AS BUILT

COMMONWEALTH OF VIRGINIA
DEPARTMENT OF HIGHWAYS
PROPOSED WIDENING OF BRIDGE
RTE. 24 OVER TINKERS CREEK
TOWN OF VINTON—CITY OF ROANOKE
PROJ. 0024-149-102, B601-STA. 15+00
5-36 FT. CONC. BEAM SPANS

CCIX-7
Sheet 1 of 18

PLAN

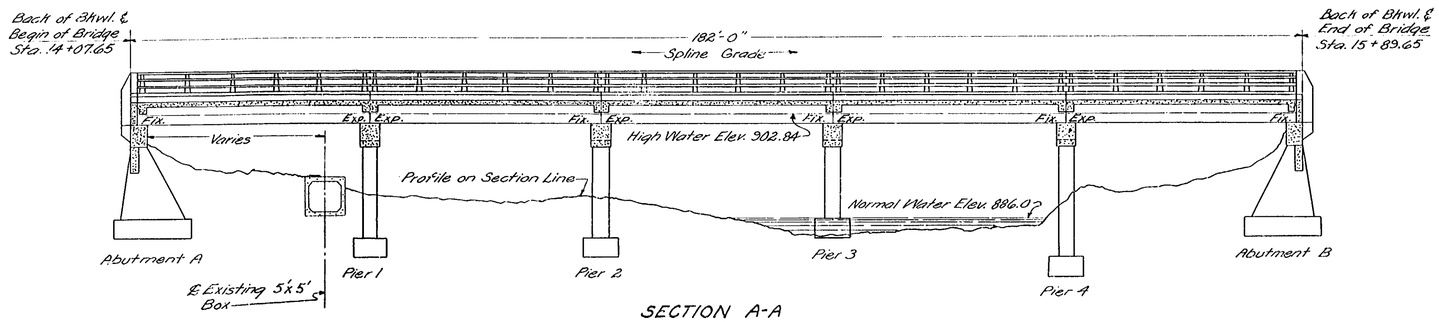
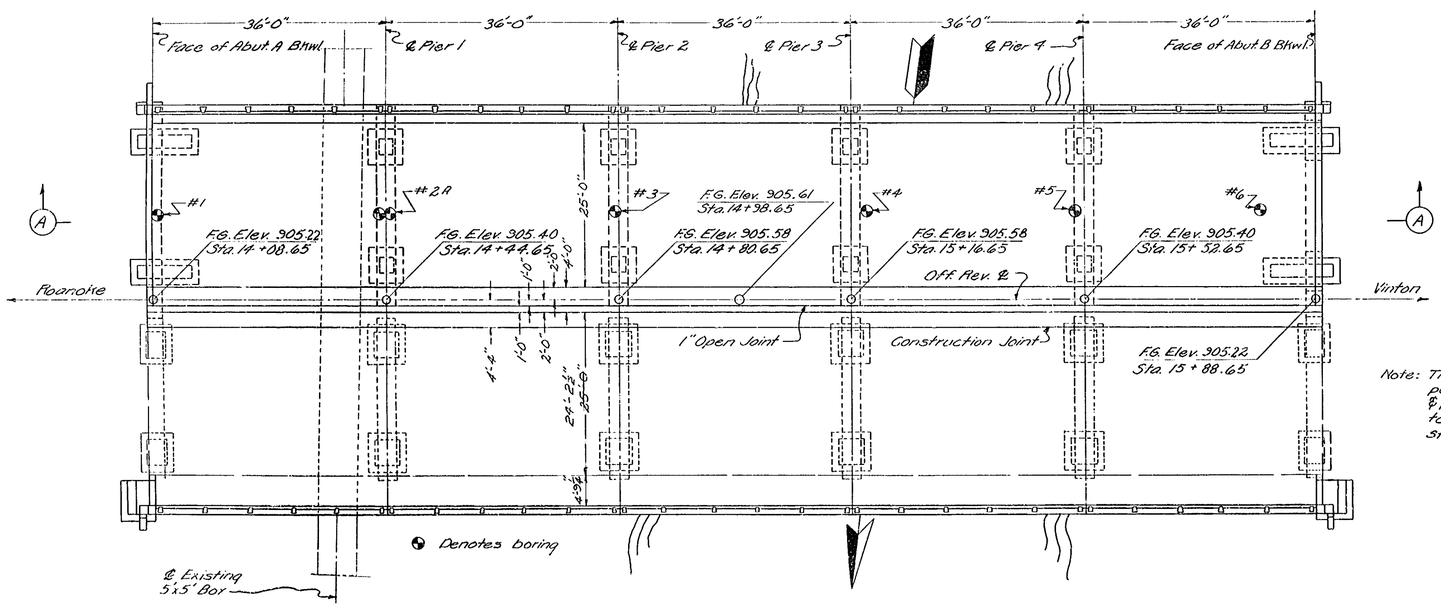
Roadway: ~~28'-0"~~ 24'-2½" clear EBL & 25'-0" clear WBL. 1-4'-9¼" sidewalk. 4'-0" median strip.

SUPERSTRUCTURE

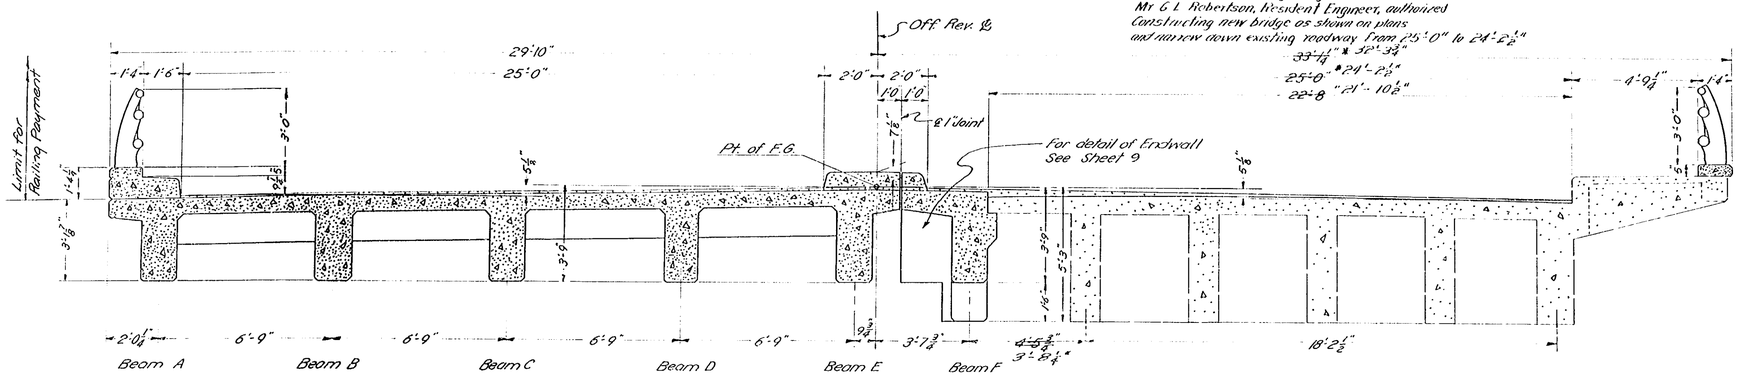
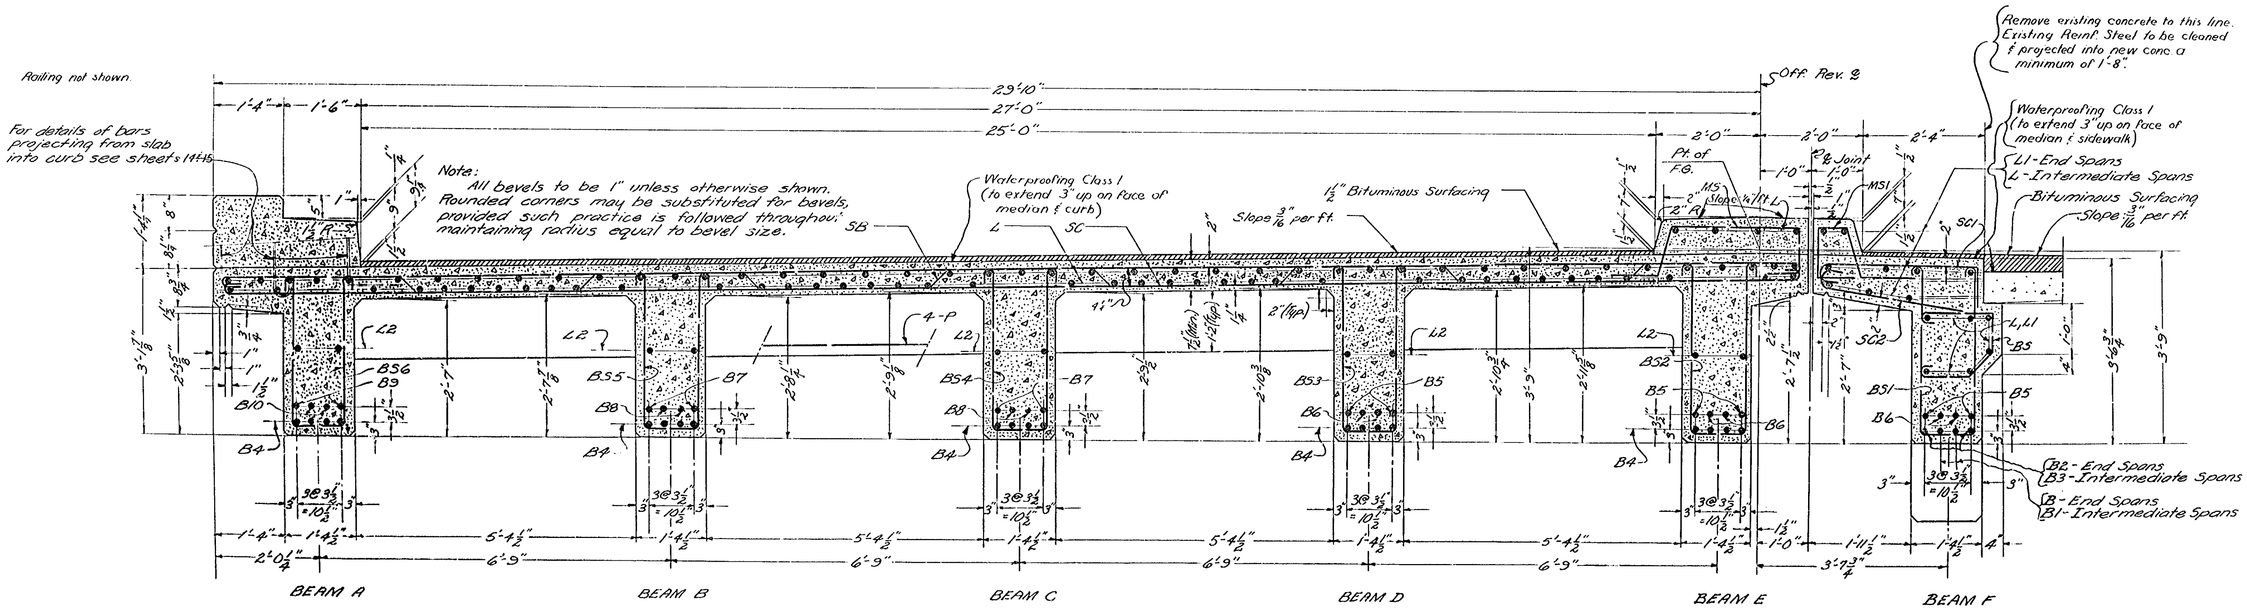
* Due to error in existing bridge width, Mr G. L. Robertson, Resident Engineer, authorized constructing new bridge as shown on plans and narrow down existing roadway from 25'-0" to 24'-2½"

WASHER-WA
(120 Required)
Scale: 6" = 1'-0"

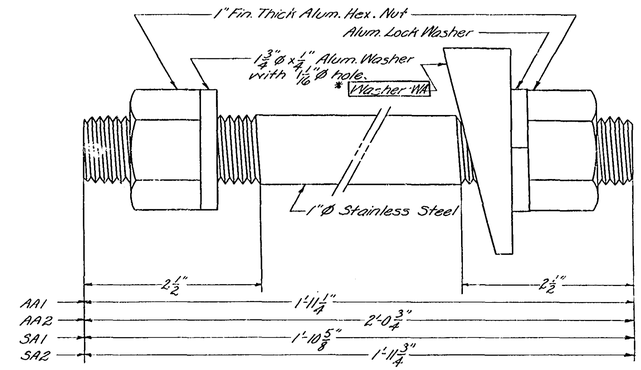
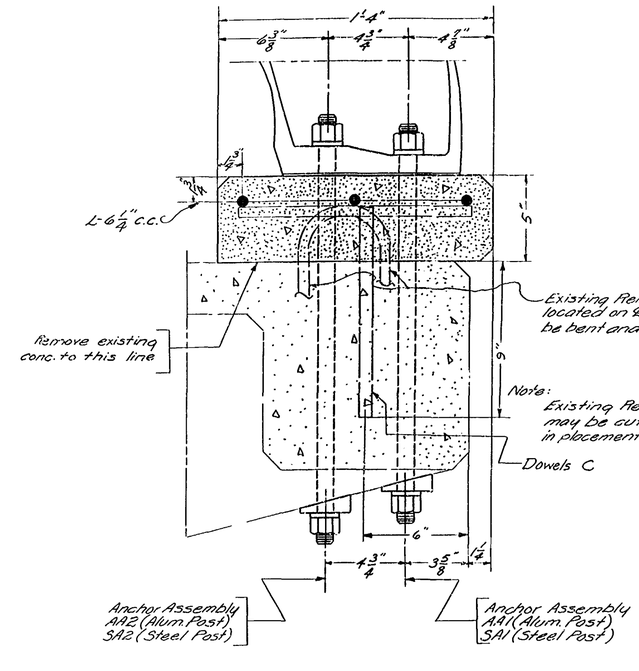
* Washer-WA was eliminated due to varying thickness of existing sidewalk and overhang in order to obtain a full nut. Authorized by Mr. D.V. Crawford, Dist. Bridge Engineer.
